Job No. 15473-3A

Subject: Addendum to Geotechnical Investigation Report
Response to Geotechnical Review Sheet
Proposed Oakmont of Agoura Hills Senior Facility
29353 Canwood Street
Agoura Hills, California

CITY OF AGOURA HILLS - GEOTECHNICAL REVIEW SHEET

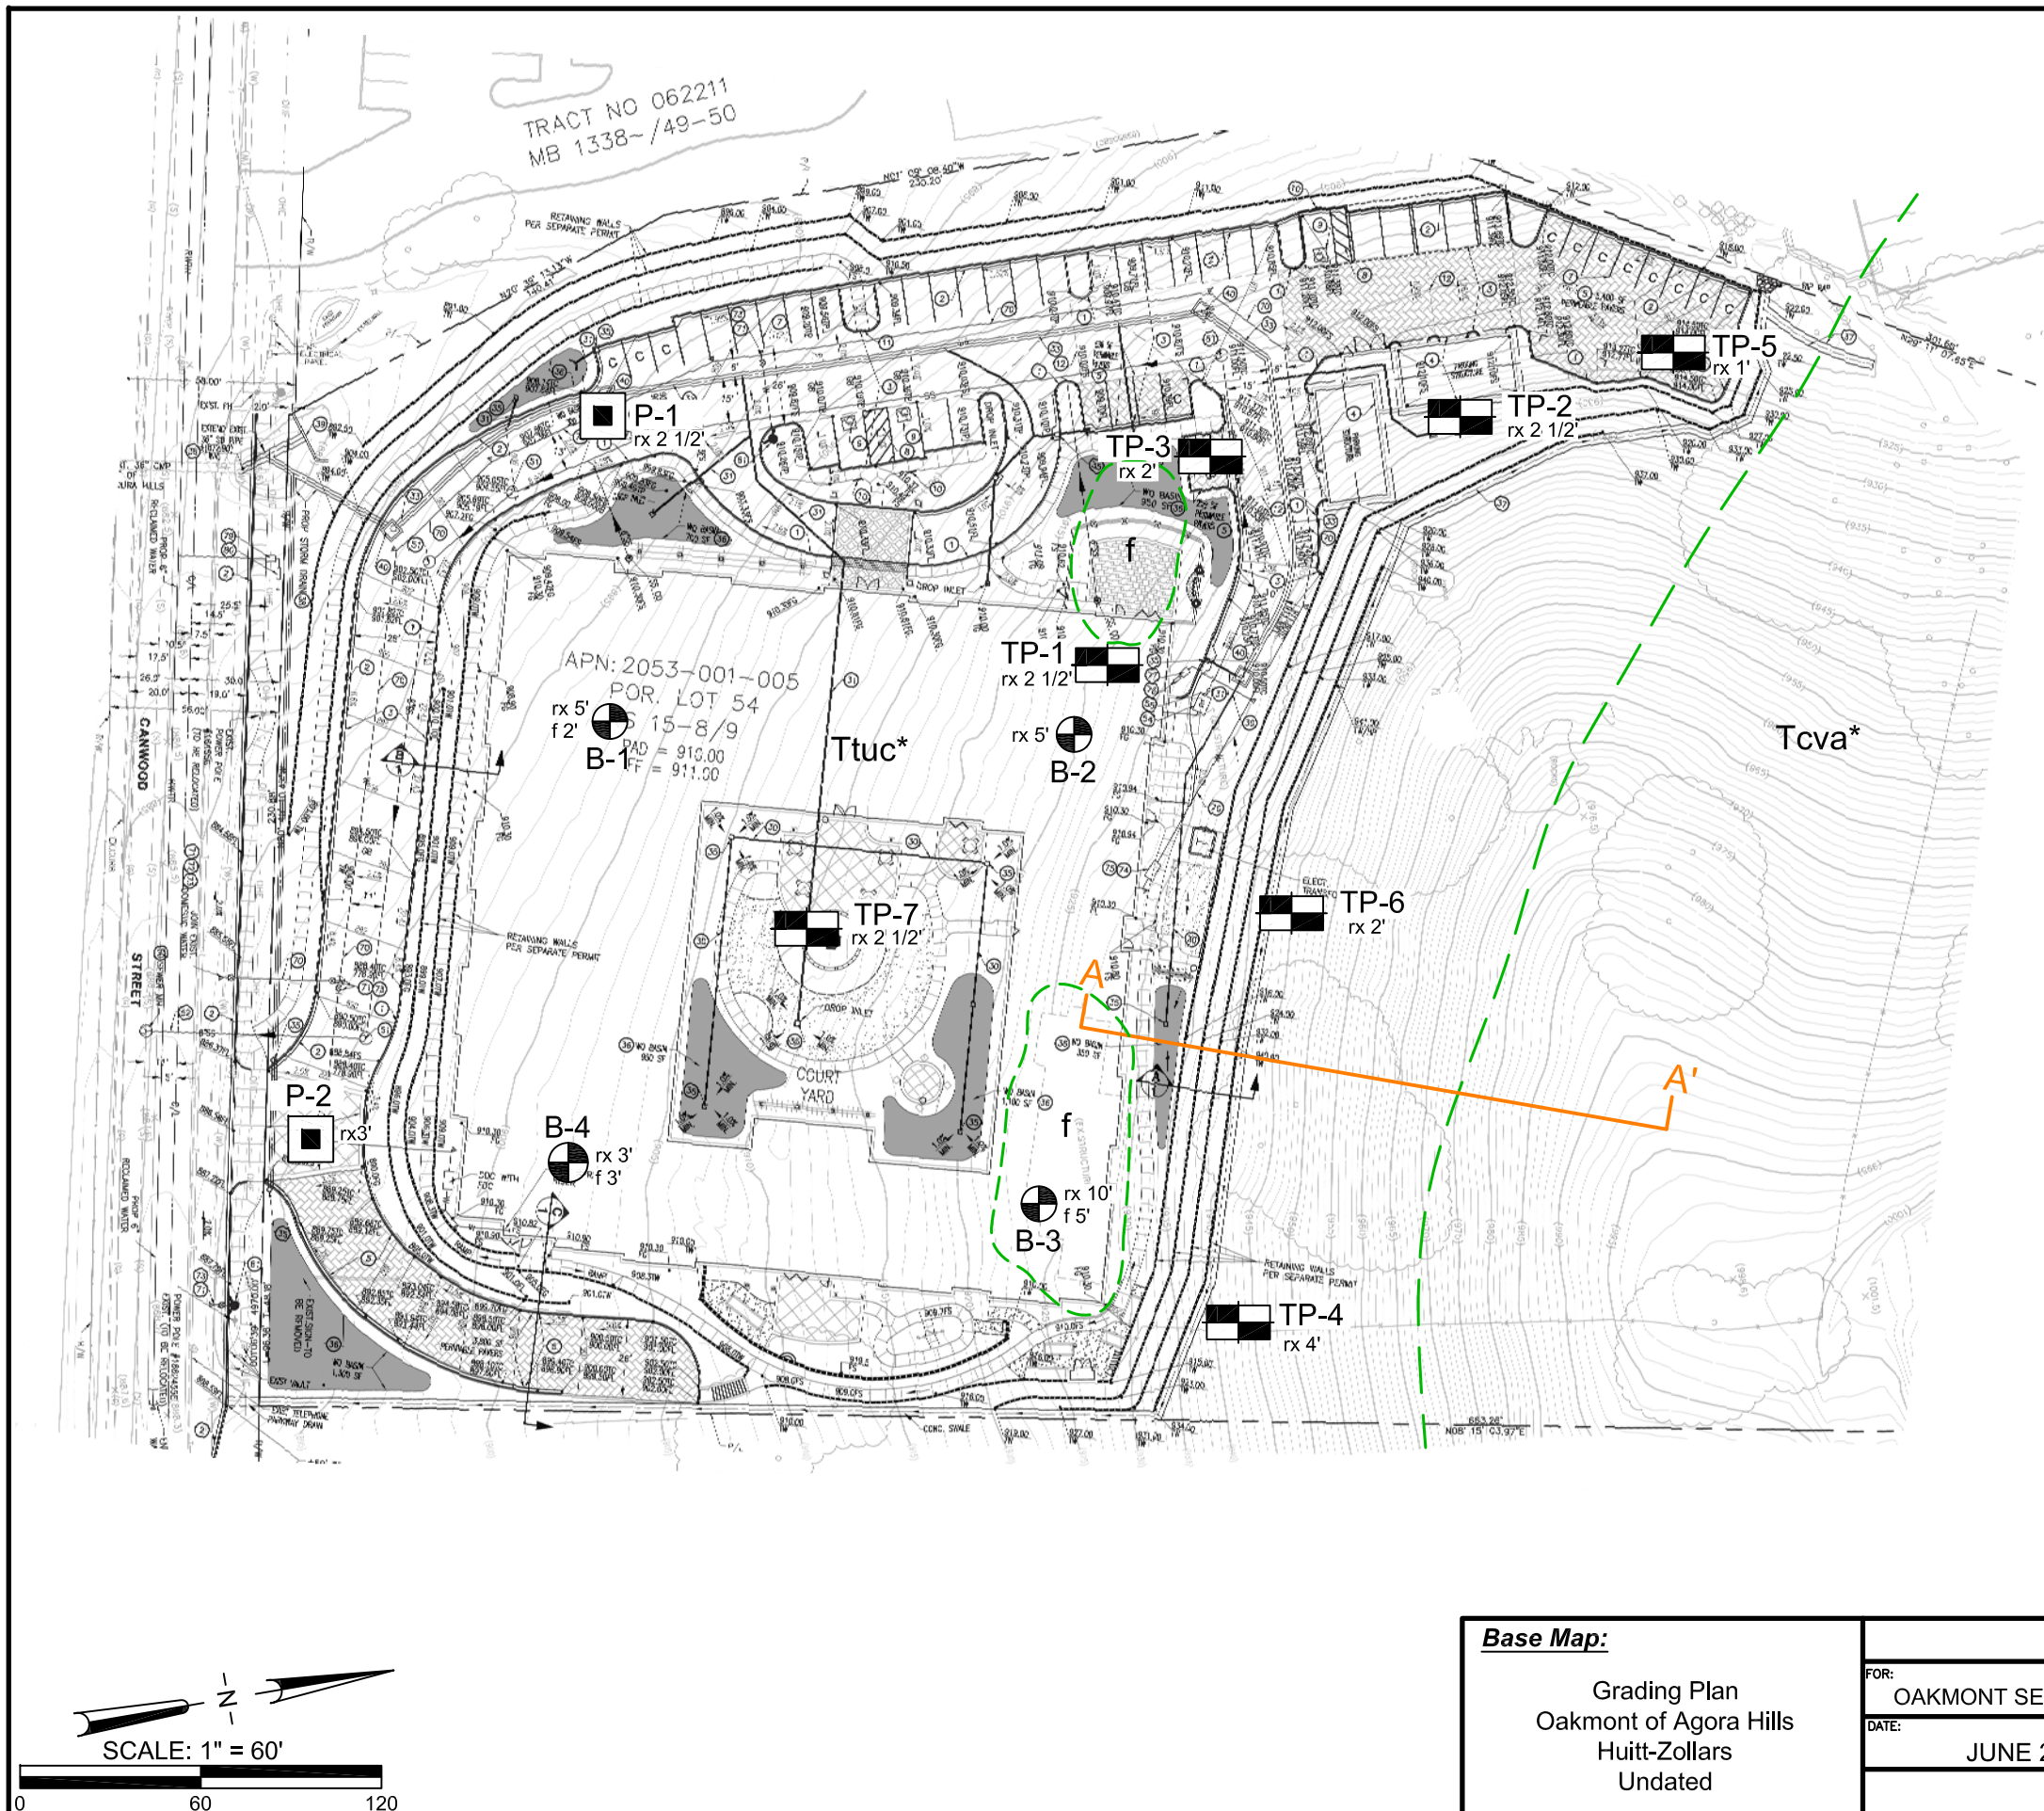
- 1. The consultant should provide an updated geologic map based on a legible copy of the latest development plan. The map should include all geologic data including contacts between all geologic units (including alluvial units if appropriate), structural information and a complete geologic legend. The consultant should discuss the basis for the location of the contact between Tcva and Ttuc (sic) indicated on the map.*

1. The consultant should review development plans as they become available to verify compliance with recommendations in the above-referenced reports. A geotechnical map using the proposed grading plan as a base map should be included. Cross sections should be updated as necessary

An updated geological and geotechnical map on the basis of the proposed grading plan, prepared by Huitt-Zollars, Inc., dated (last saved) April 16, 2016, is attached hereto.

An updated geological and geotechnical map on the basis of the proposed grading plan, prepared by Huitt-Zollars, Inc., dated (last saved) April 16, 2016, is attached hereto.

GEOLOGIC CROSS SECTION A-A'		
FOR:	OAKMONT SENIOR LIVING	ENCLOSURE "A-2.2"
DATE:	JUNE 2016	JOB NUMBER 15473-3A
GEOTECHNICAL INVESTIGATION OAKMONT OF AGOURA HILLS SENIOR FACILITY APN 2053-001-005 29353 CANWOOD STREET AGOURA HILLS, CALIFORNIA

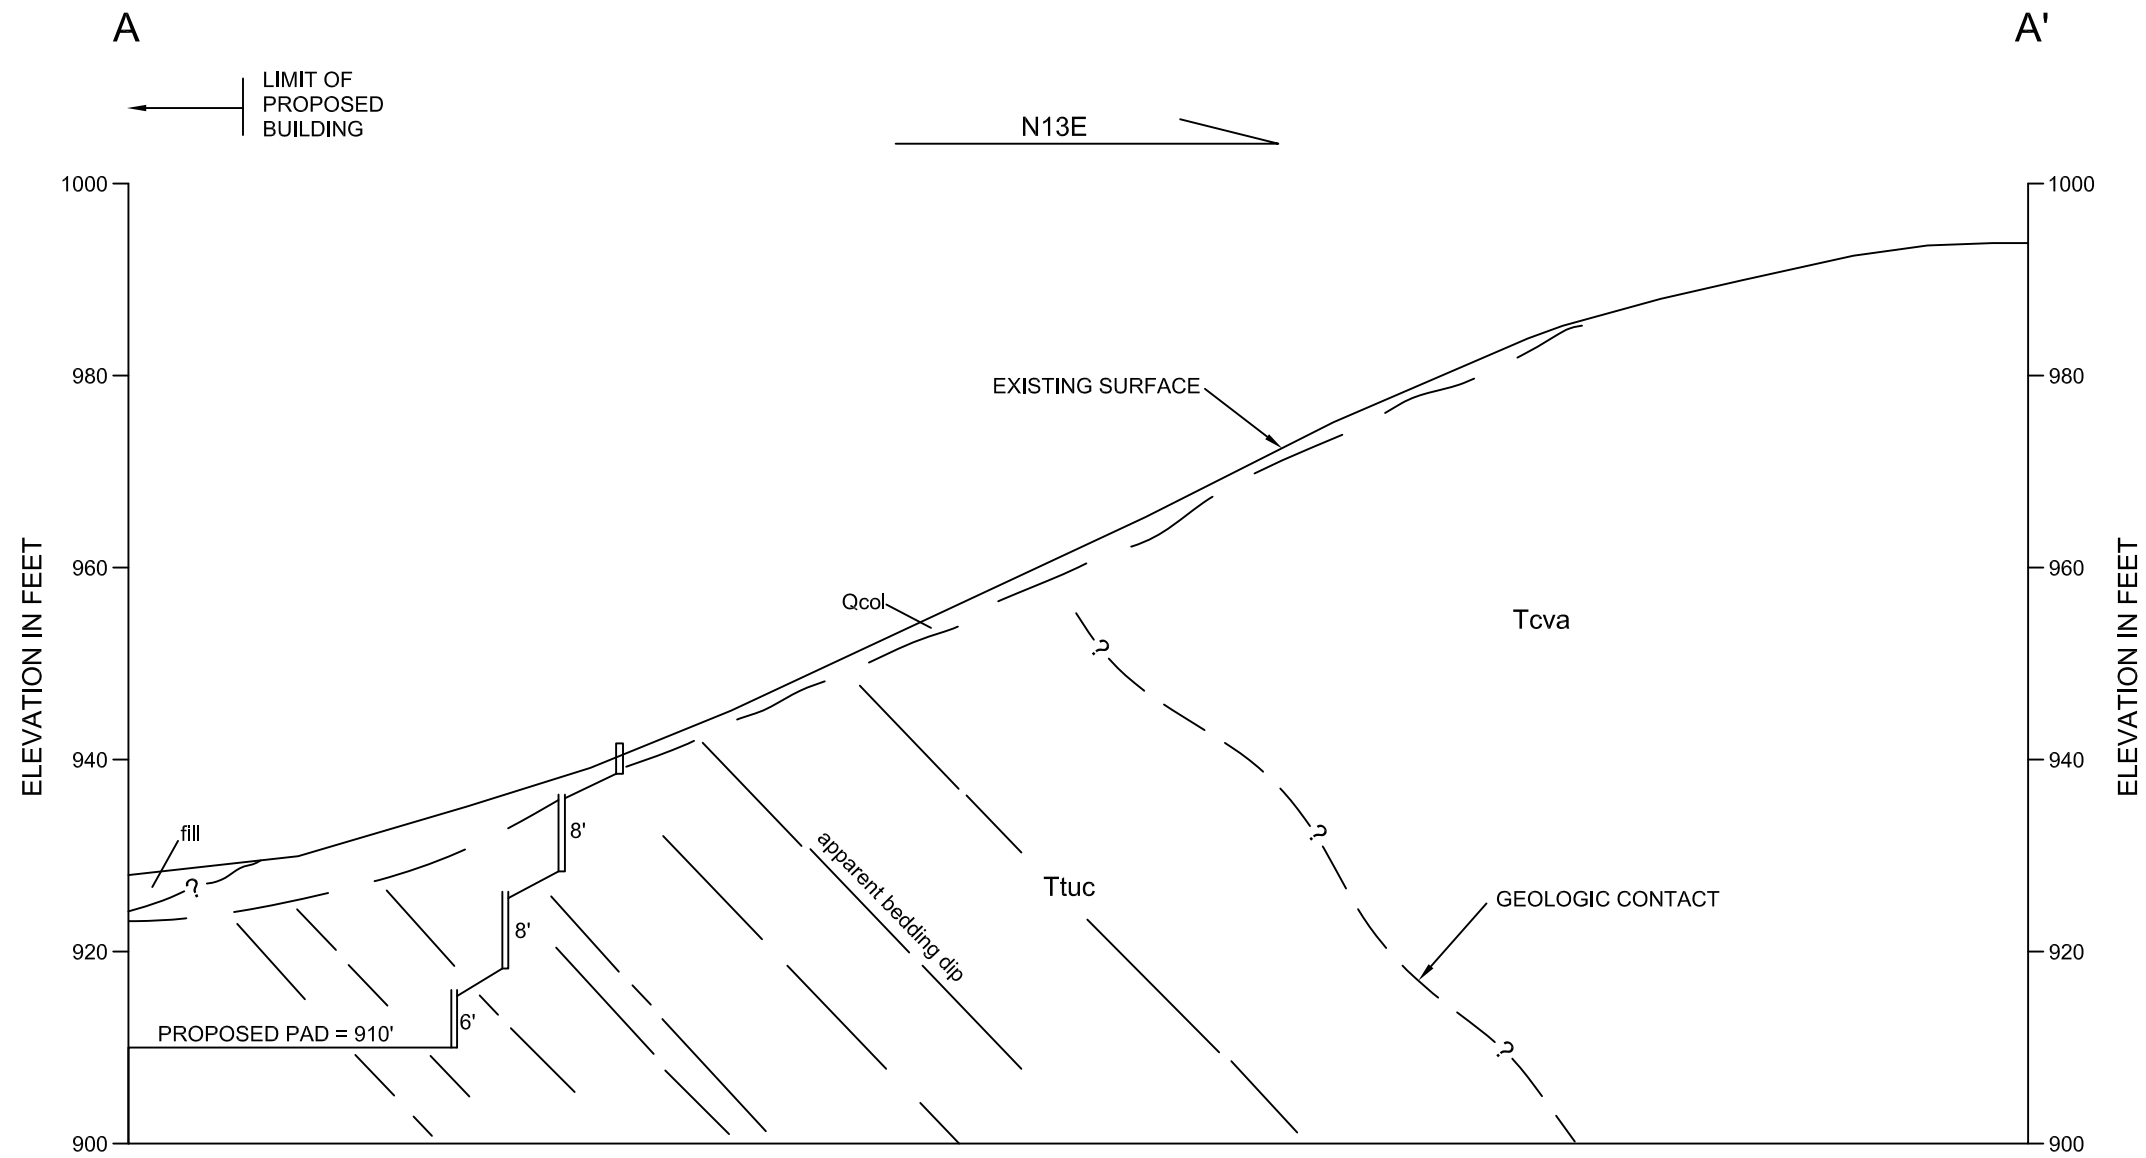
3. Cross sections should be provided through the slope and proposed retaining walls along the north edge of the building pad.

A cross section illustrating the relationship of existing grades and topography to the proposed building pad, retaining walls and recommended removal depth is attached hereto.

BUILDING SETBACK DETAIL		
FOR: OAKMONT SENIOR LIVING	GEOTECHNICAL INVESTIGATION OAKMONT OF AGOURA HILLS SENIOR FACILITY APN 2053-001-005 29353 CANWOOD STREET AGOURA HILLS, CALIFORNIA	ENCLOSURE "B-1"
DATE: JUNE 2016		JOB NUMBER 15473-3A
CHJ Consultants

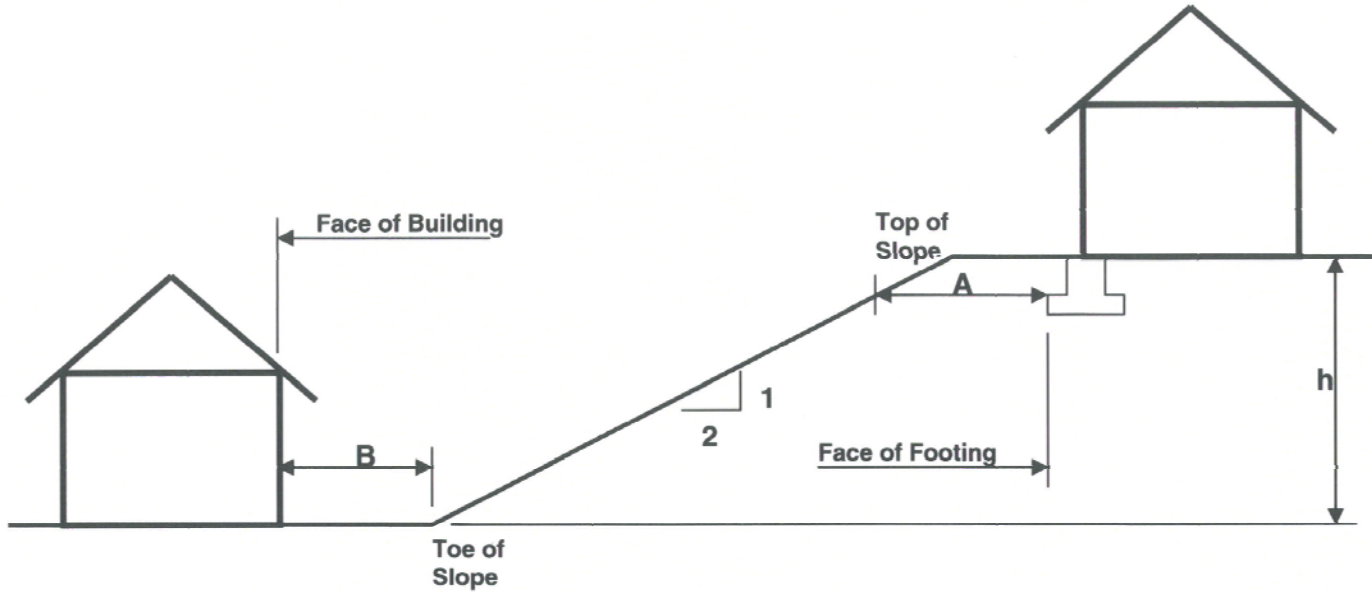
- 4. The consultant should provide recommendations for the foundation to slope setback in accordance with the City of Agoura Hills building ordinance.*

Foundations on or adjacent to slope surfaces shall be designed in accordance with 2013 CBC, Section 1808.7.2. The minimum setback from the slope surface is shown in Enclosure "B-1".

Project				SLIDE - An Interactive Slope Stability Program					
	Analysis Description									
	Drawn By		CHJ Consultants		Author		F.Yi		Scale	1:300
	File Name		15473-3A Section D-D.slim		Date		6/22/2016		Enclosure	C-1

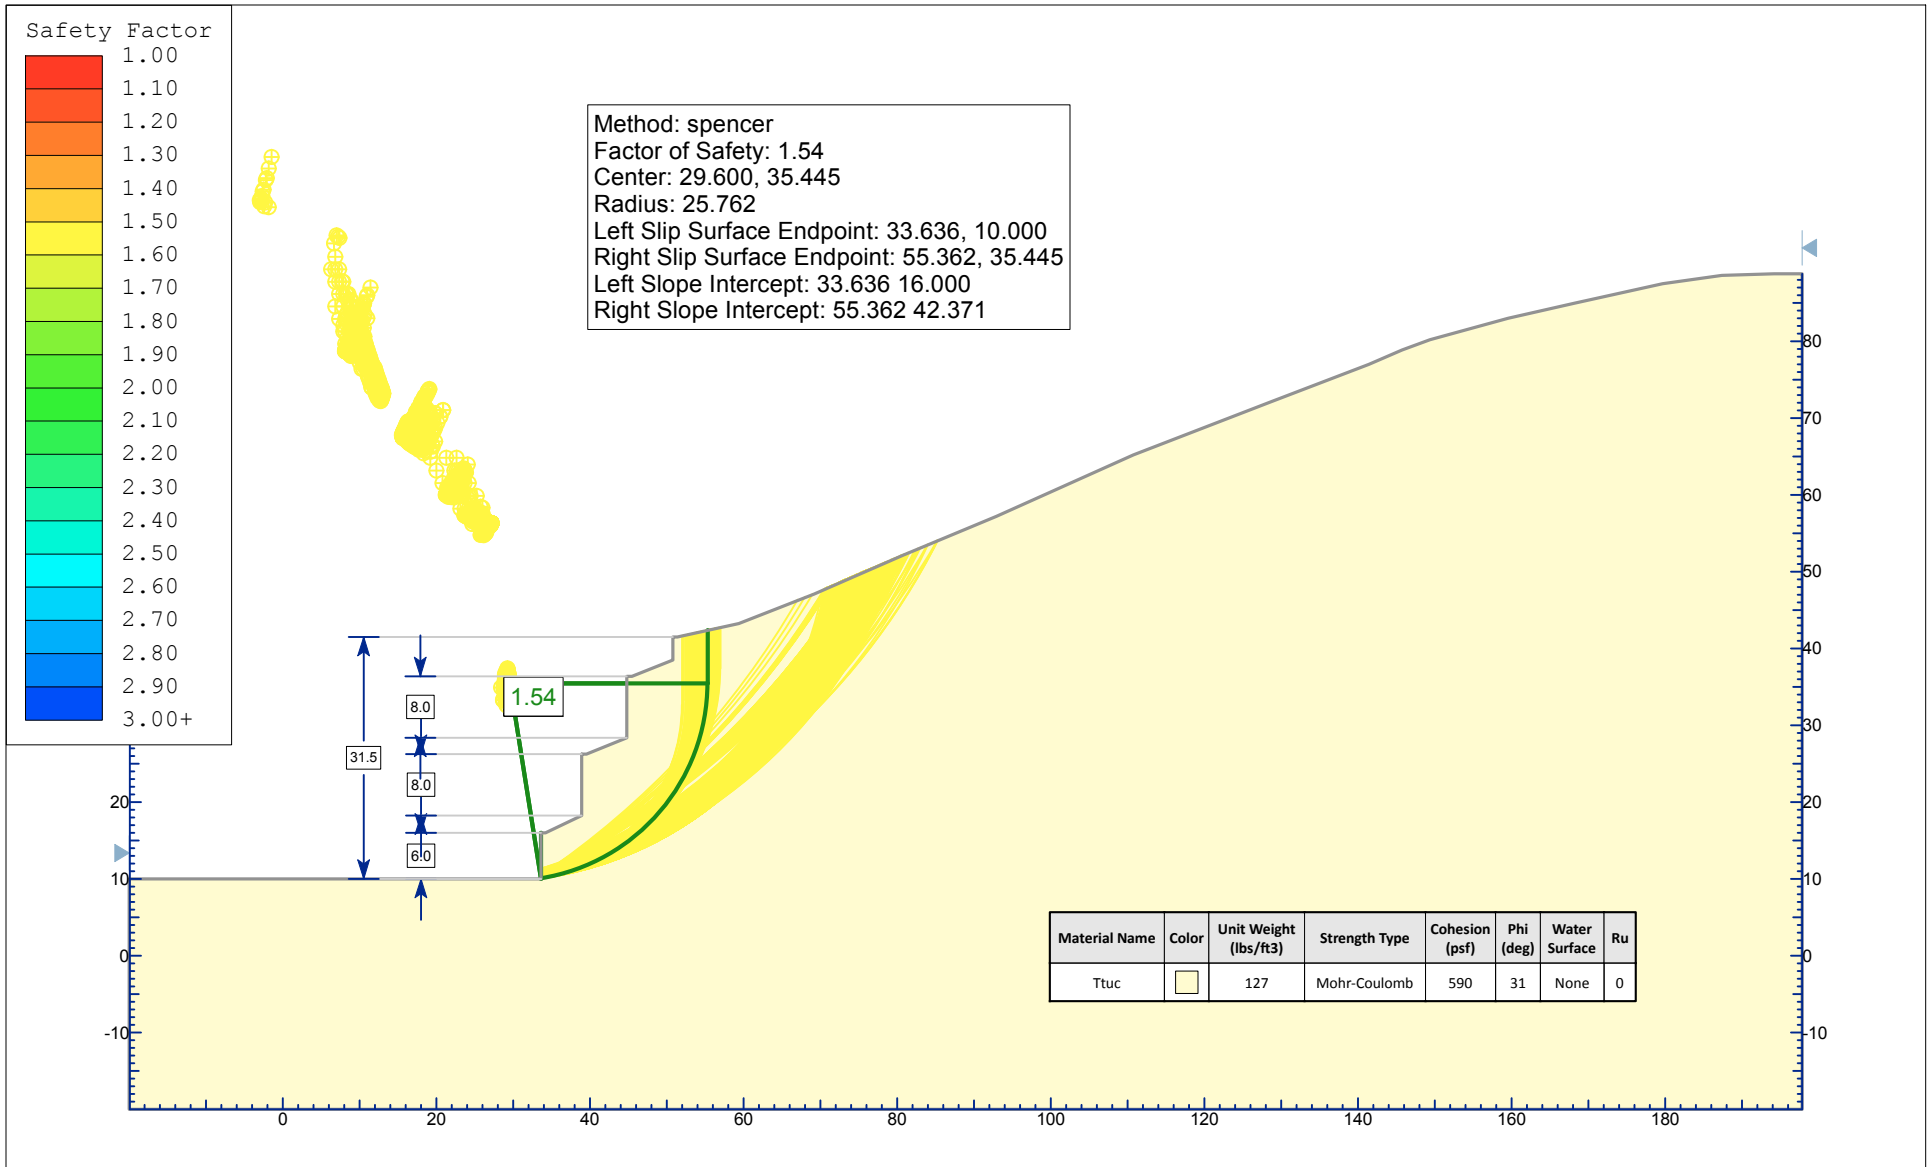
6. The consultant should discuss and evaluate as necessary the stability of all slopes that would impact the proposed development at the site. Mitigation measures should be recommended as necessary.

The stability of the proposed cut slope was evaluated using a computer program, Slide 6.039 (Rocscience, 2016). Based on the grading plan, the highest cut slope is approximately 31.5 feet in total height. According to Seismic Hazard Zone Report 042 (Seismic Hazard Zone Report For The Thousand Oak 7.5-Minute Quadrangle, Ventura And Los Angeles Counties, California, California Geological Survey, 2000), the mean/medium frictional angle is of 33/31 degrees and the mean/medium cohesion strength is of 591 psf for Group Ttc2 (Ttuc for the subject site) material. We used a frictional angle of 31 degrees and cohesive strength of 590 psf in our slope stability calculations.

The results of static and seismic stability are shown in Enclosures "C-1" and "C-2". The results indicate factors of safety of 1.54 under a static condition and 1.19 under a seismic condition. Both satisfy the minimum values for required factors of safety.
